VIRGINIA ELECTRIC AND POWER COMPANY
RICHMOND, VIRGINIA 23261

Serial No. 01-327A
NL&OS/ETS R0
Docket Nos. 50-338/-339
License Nos. NPF-4/-7

VIRGINIA ELECTRIC AND POWER COMPANY
NORTH ANNA POWER STATION UNITS 1 AND 2
INSERVICE TESTING PROGRAM FOR PUMP AND VALVES
THIRD TEN YEAR INTERVAL UPDATE
REQUEST FOR ADDITIONAL INFORMATION

**North Anna Unit 1
Inservice Testing Program
Revised Relief Requests**

OUTSIDE RECIRCULATION SPRAY PUMP 1-RS-P-2A

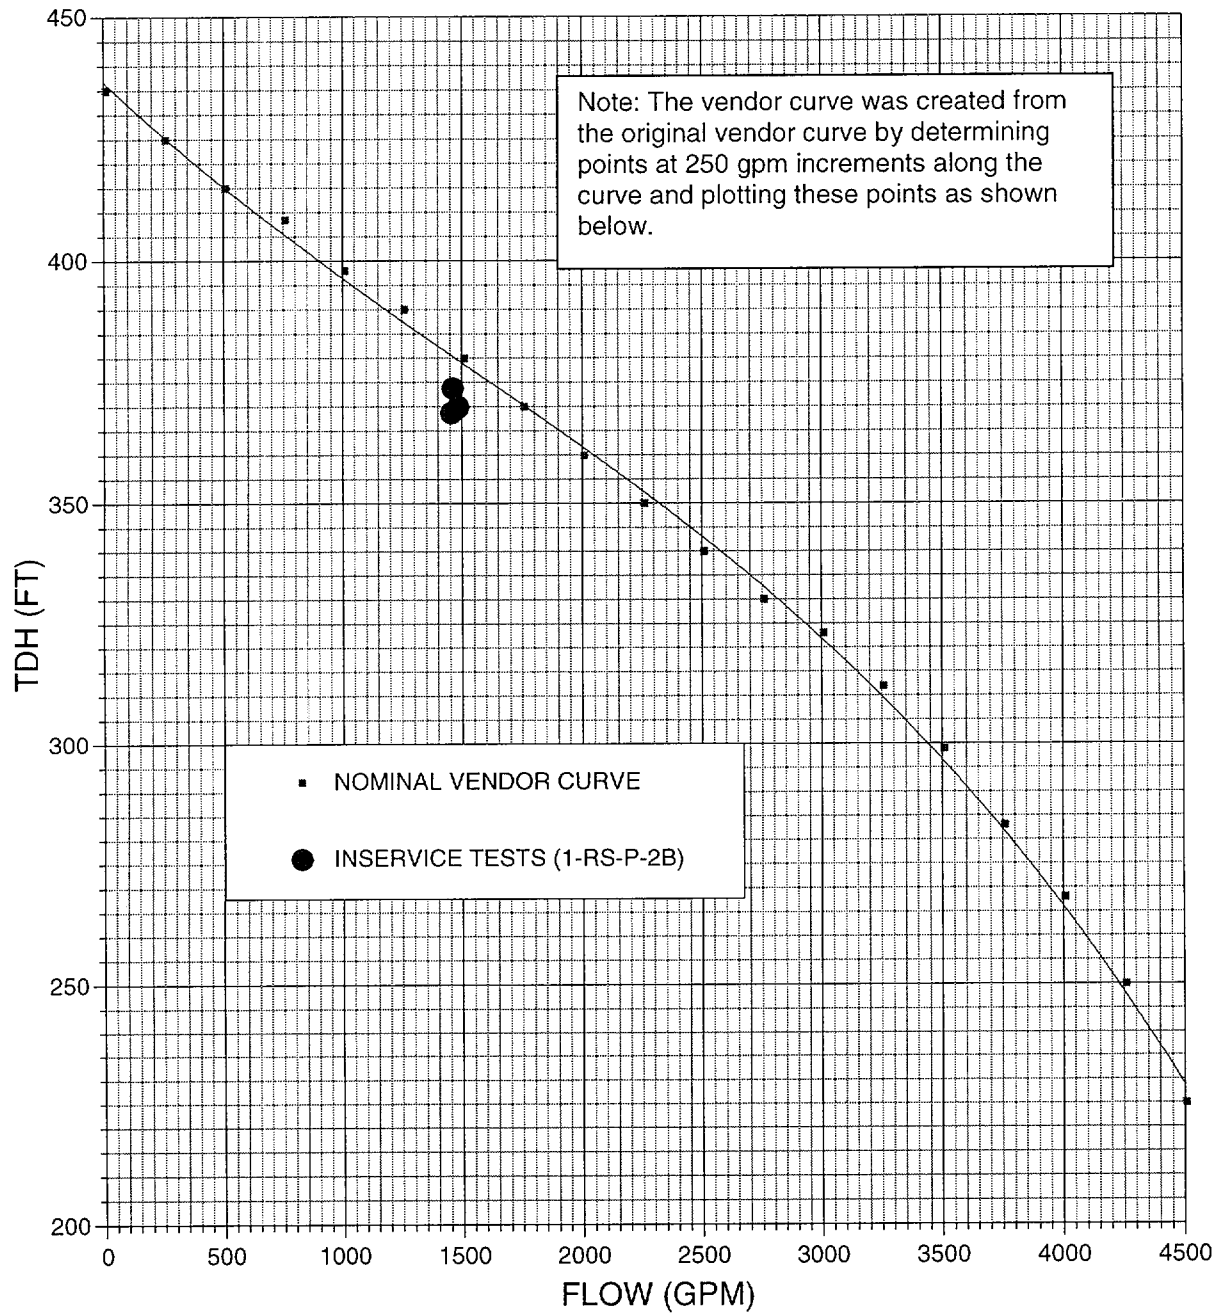
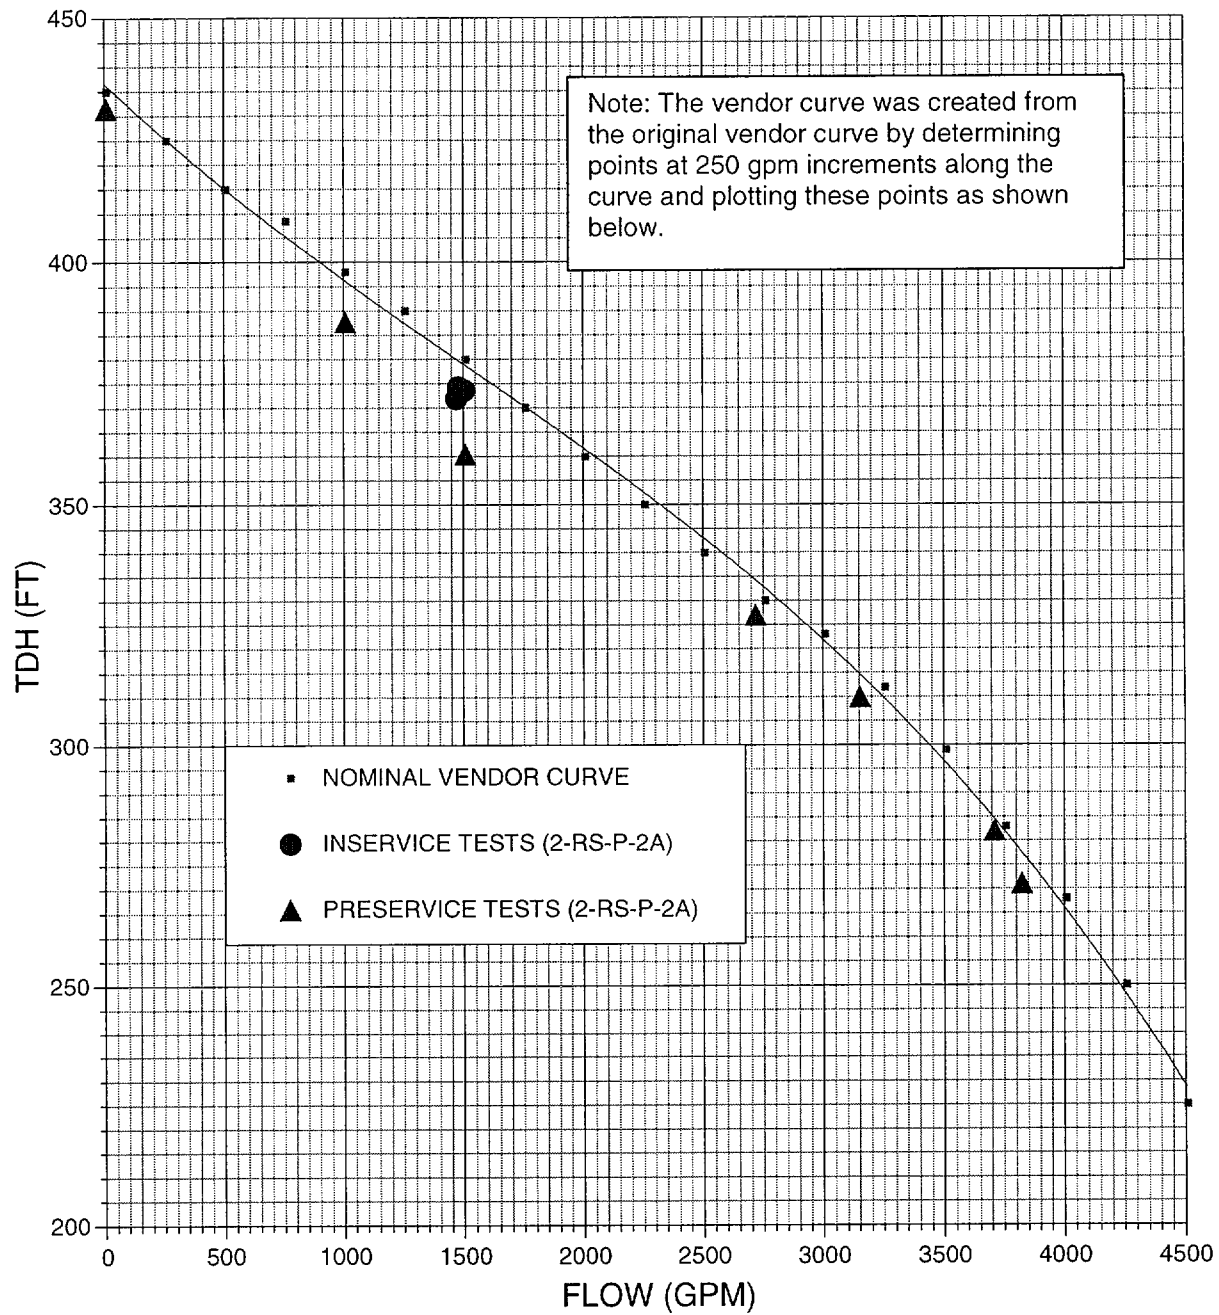
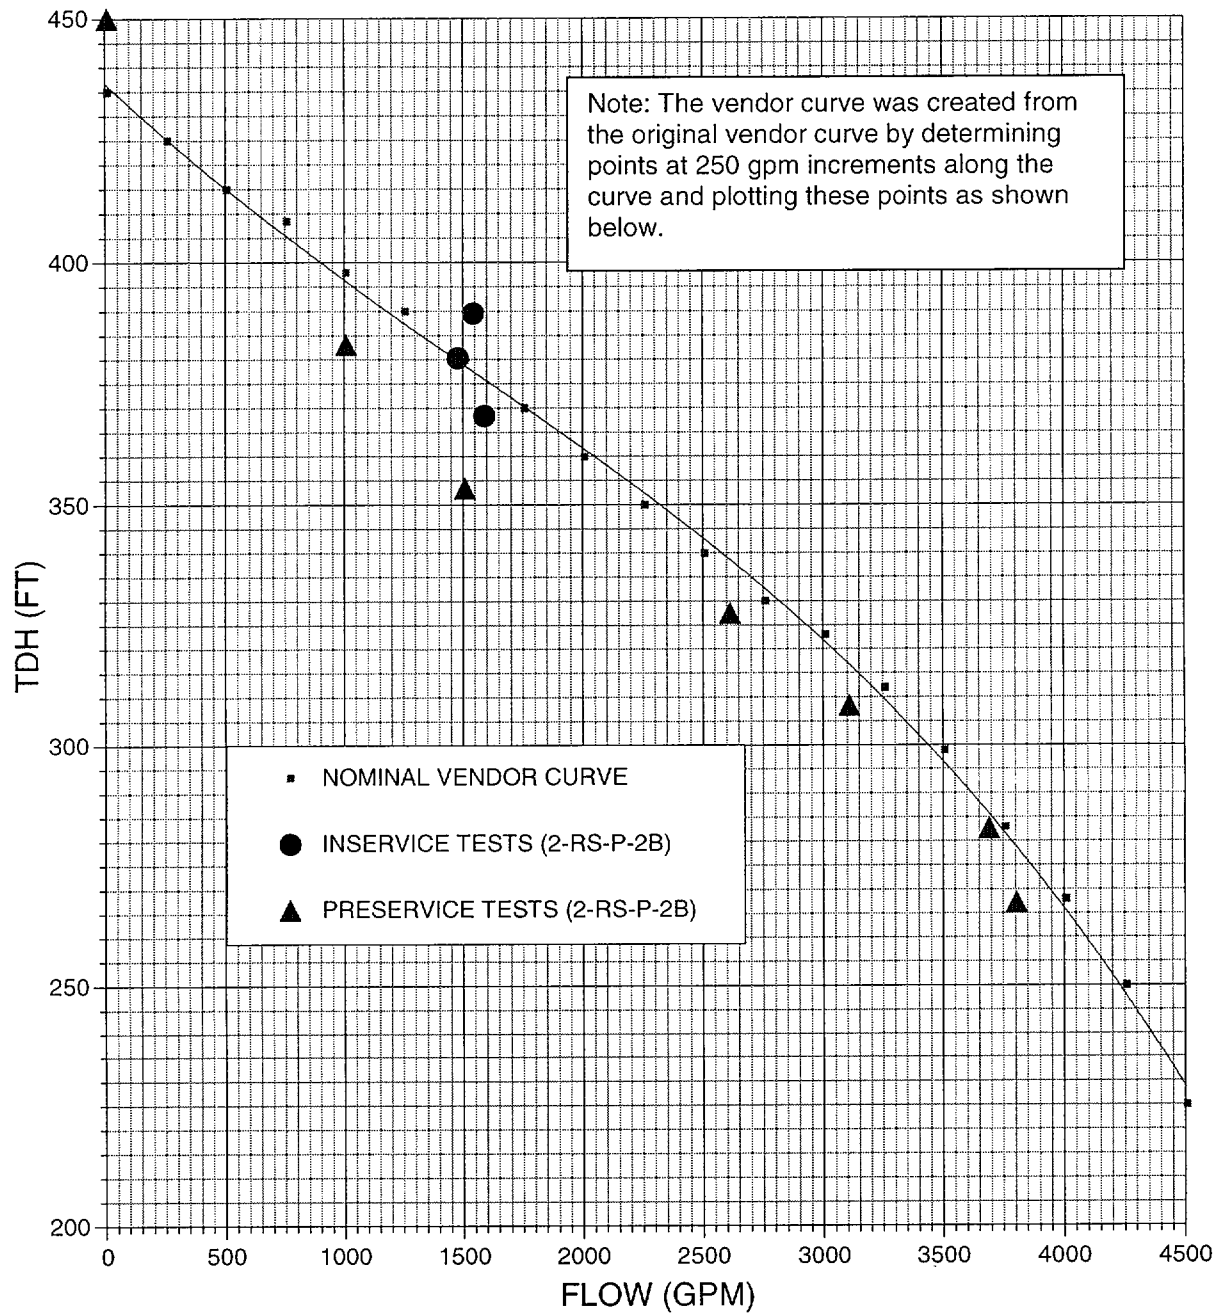
RELIEF REQUEST NO.	DESCRIPTION OF CHANGE
	Unit 2 pumps. There were no preservice tests performed for the Unit 1 pumps.
P-7	For auxiliary service water pump 2-SW-P-4, the need for and consequently the request for relief from the discharge pressure instrument accuracy requirement was eliminated. Based on guidance from ASME OM Interpretation 95-6, certain terms in the instrument loop accuracy calculation can be excluded, resulting in a calculated value for loop accuracy that is within $\pm 2\%$. In the alternate testing section, 10 CFR 50.55a(a)(3)(i) was added as a reference.

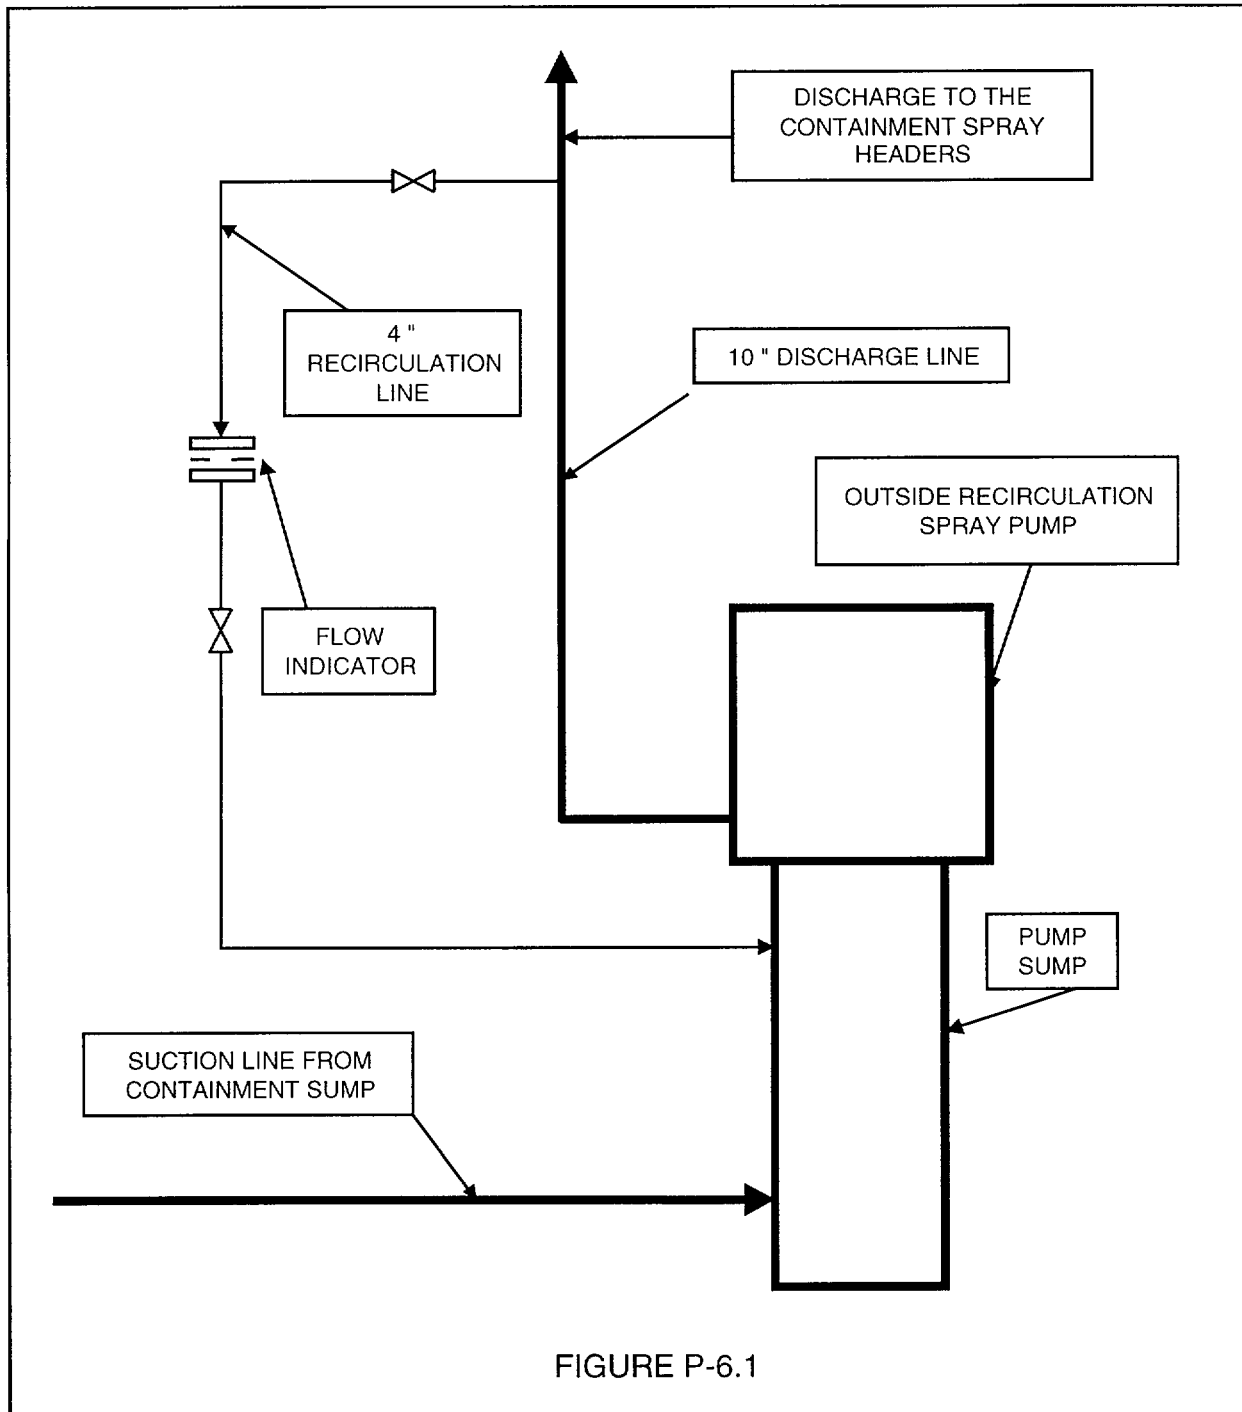
The test loop for the outside recirculation pumps consists of a 10" pump discharge line feeding into a 4" recirculation line which feeds back to the pump sump. Refer to Figure P-6.1. With this test loop, pump design flow cannot be established. Also, the discharge piping was not designed to be temporarily reconfigured so that pump design flow could be achieved.

As an alternative to flow testing at the design flow rate, the test loop shown in Figure P-6.1 will be used. Reference flows are typically established with this test loop in the range of 1450 to 1500 gpm, whereas the pump design flow is 3640 gpm. The low reference flows result from restrictions due to the small 4" recirculation line and the limited volume of water in the test loop. The limited water volume results in a rapid temperature rise in the test loop due to heat loads added by the running pump. This temperature rise affects repeatability of the measured hydraulic parameters. Therefore, care must be taken to ensure that the pump run time is limited and that the flow rate is maintained within an optimal range.

FIGURE P-6.2

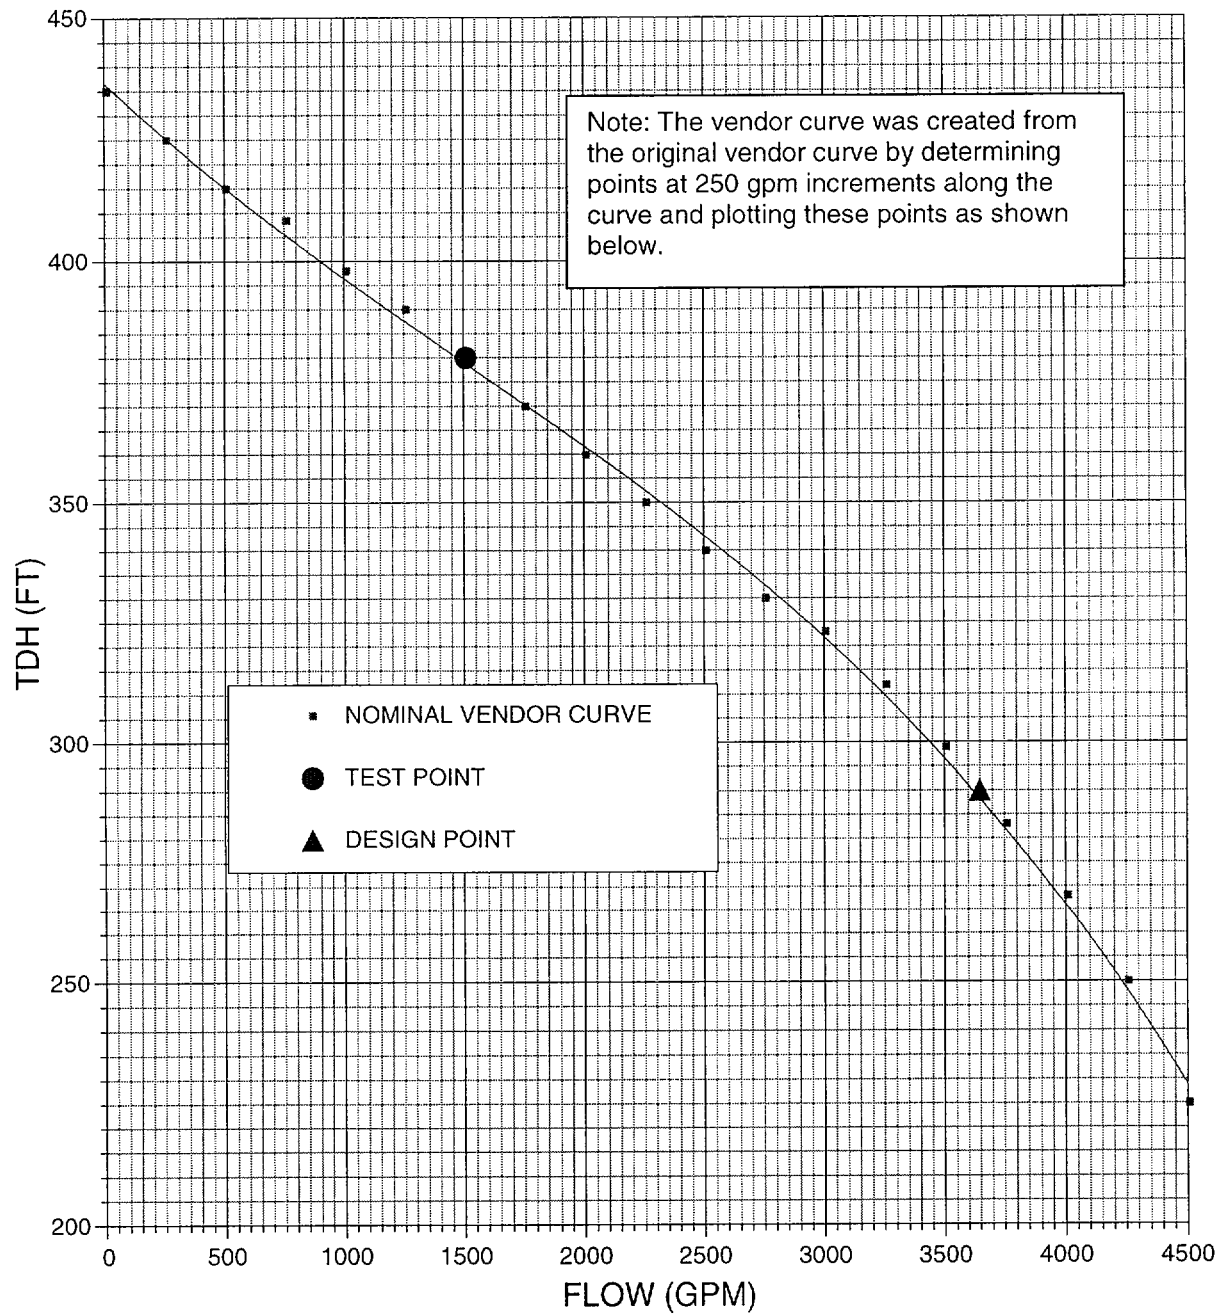
In the 1450 to 1500 gpm range of the head curve for these pumps, the head curve is not flat, but well sloped. Refer to Figure P-6.2. Therefore, as performance degrades due to internal recirculation caused by increasing internal pump clearances, the differential pressure will measurably decrease for a given reference flow rate. As discussed above, testing the outside recirculation spray pumps over the full range of the pump curve and measuring at least five points along the curve is impractical.

As an alternative to testing within 20% of the design flow, the reference values will be established at approximately 40% of the design flow. It is our understanding that testing at design flow is important for pumps with characteristic head-flow curves that are flat or gently sloping in the low flow region (little change in developed head with increasing flow). In the low flow region, increasing internal flows, usually due to wear, are difficult if not impossible to detect. Pumps with the "flat" curves at low flows should be tested at near design conditions to determine if increasing internal recirculation flows have degraded pump performance to the point where design requirements cannot be met. This situation does not apply to the outside recirculation pumps if they are tested at 40% of design flow. Testing at the reference flows will detect pump degradation because the pump curve is well sloped at the point of testing. Refer to Figure P-6.2.
